**NSLPP MEETING HELD ON 05/02/2025****Attachments:**

**ADDRESS:** 42 Jeffreys Street, Kirribilli**APPLICATION NO:** DA 233/2024

**PROPOSAL:** Alterations & additions to an existing dwelling, including alterations to the internal layouts, conversion of the existing attic space into a habitable living space and general maintenance works.

**OWNER:** Wenjie Chen**APPLICANT:** Sandbox Studio**AUTHOR:** Report of Jack Varka, Assessment Officer**DATE OF REPORT:** 16 January 2025**DATE LODGED:** 23 September 2024**DATE AMENDED:** 25 November 2024**RECOMMENDATION:** Approval

NO. **A18**  
PAGE SIZE. **A3**

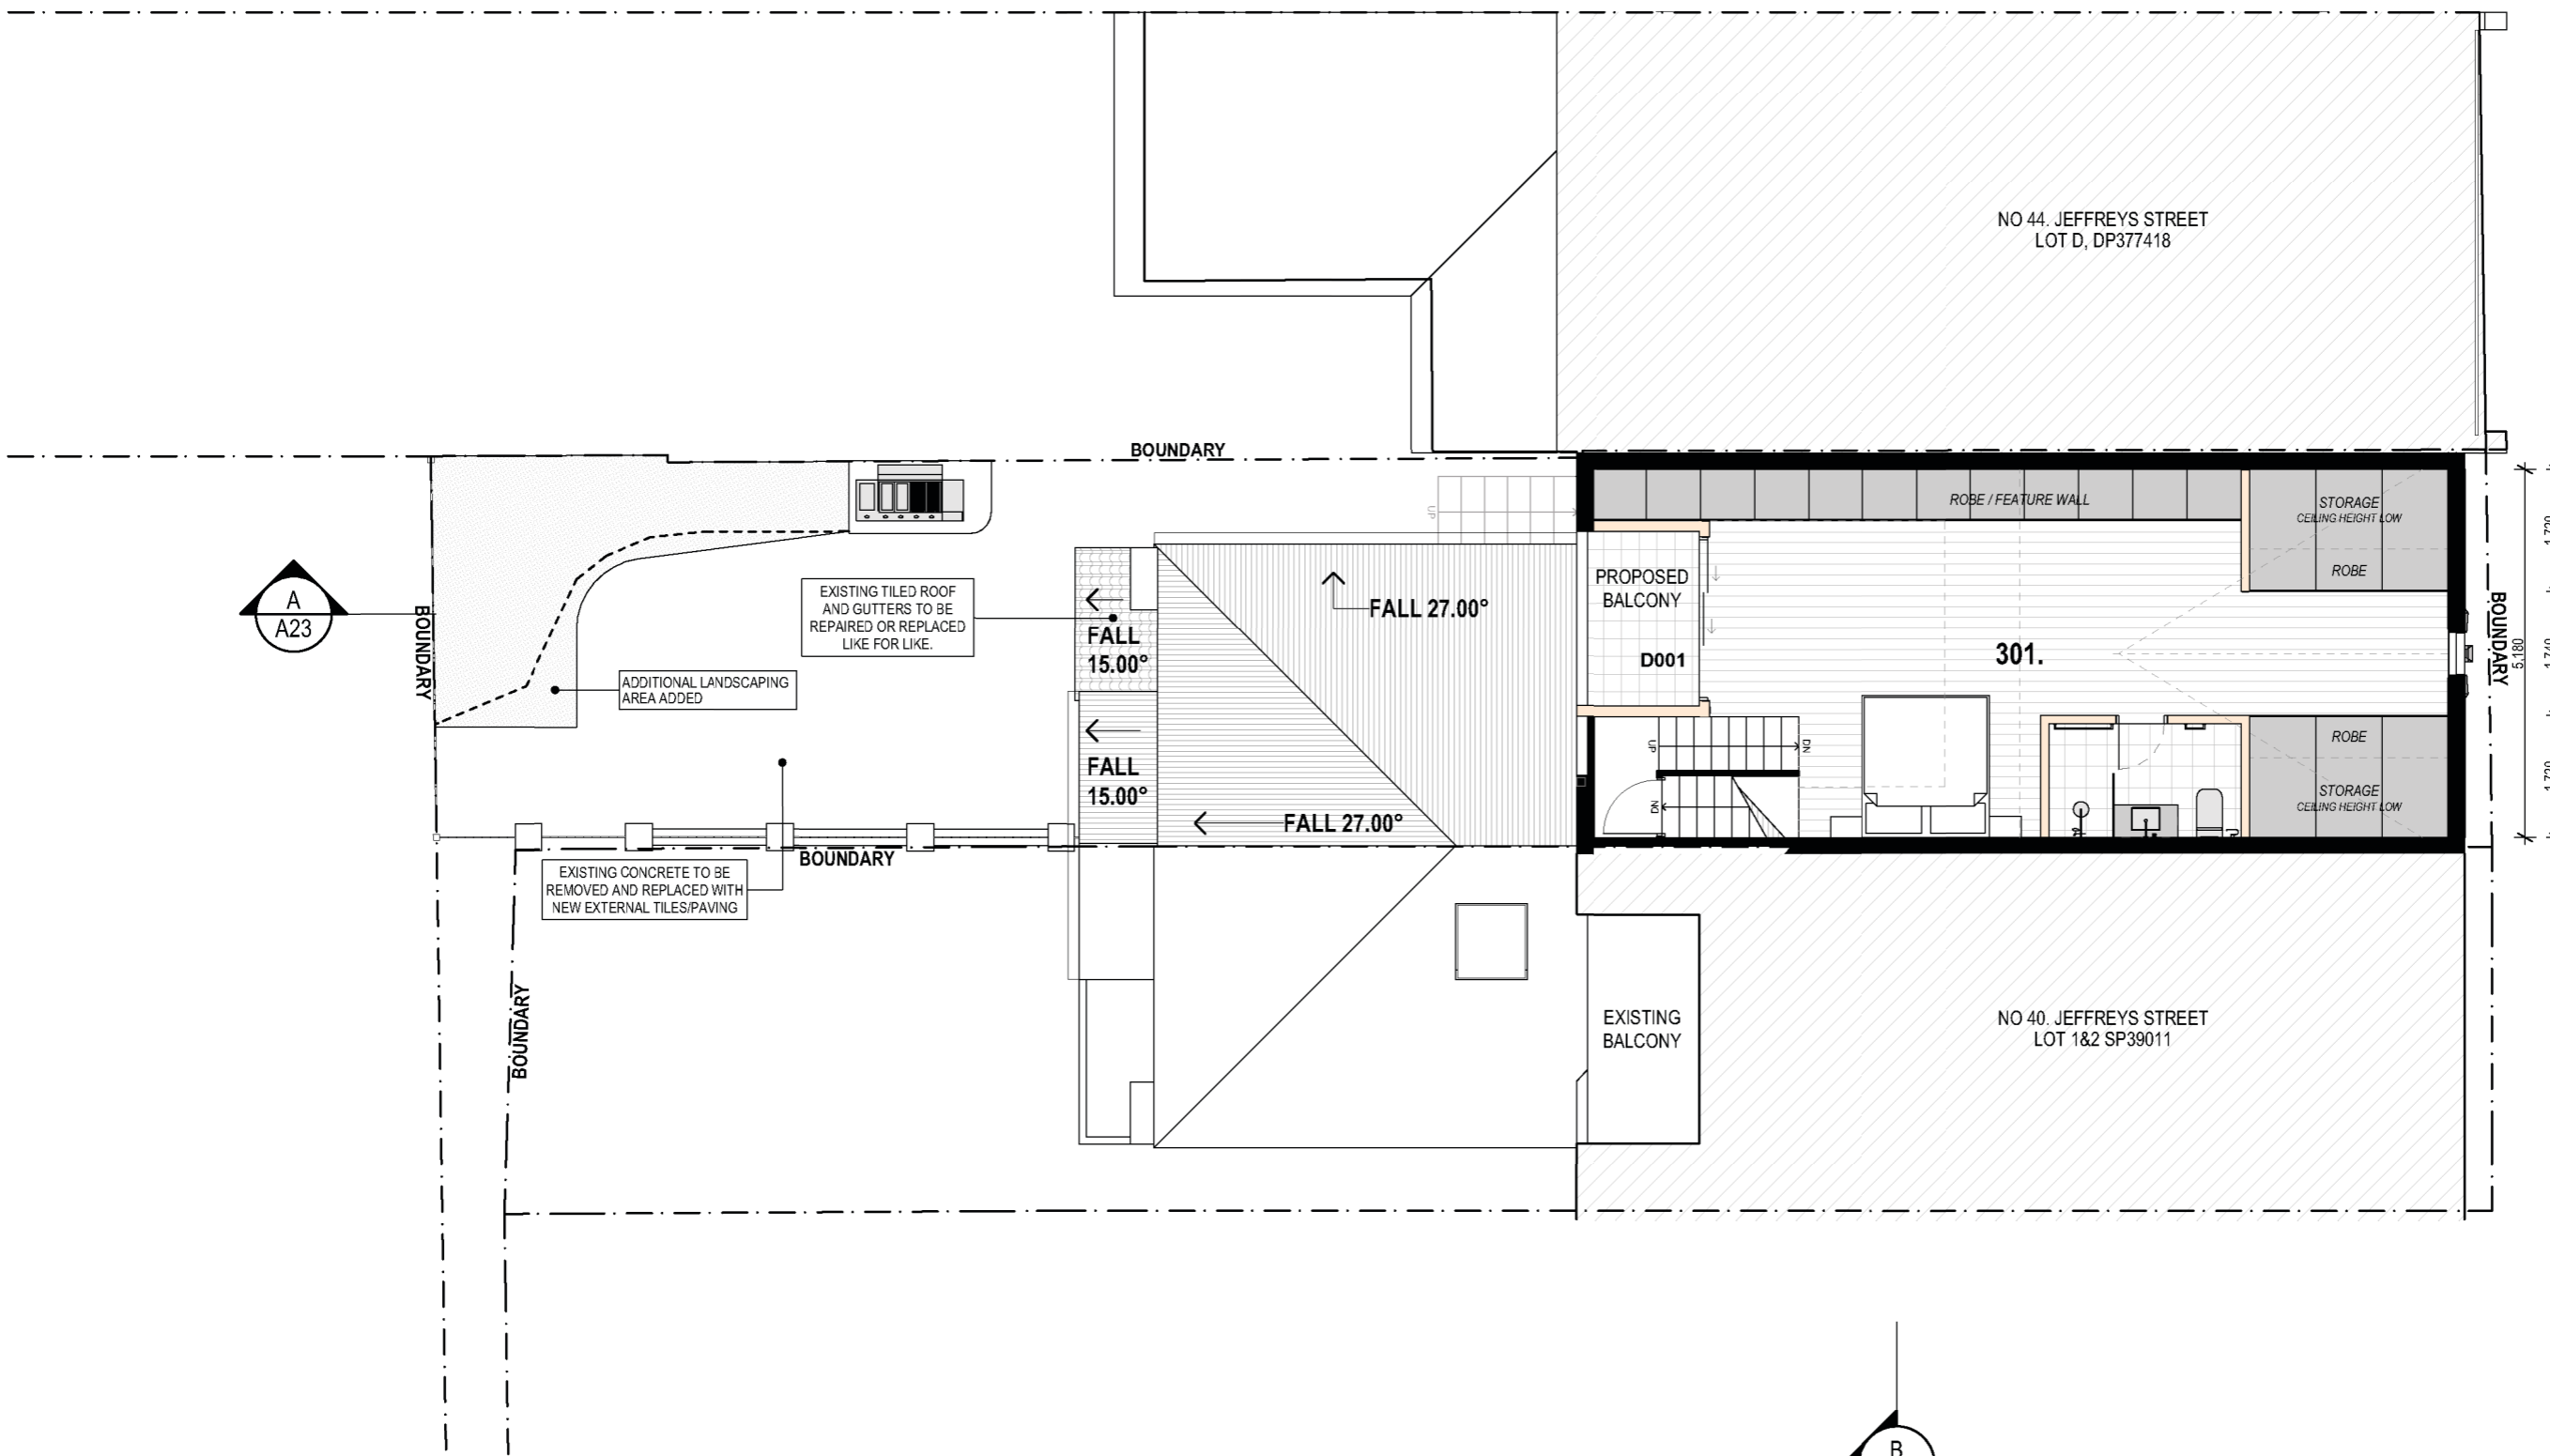
- *Confirmation through the annotation of drawing no. A18/B to indicate that the ensuite to the master bedroom will retain the existing fireplace, minimize impact to fabric so that the opportunity to enable the room to revert to its original use remain viable – see below.*
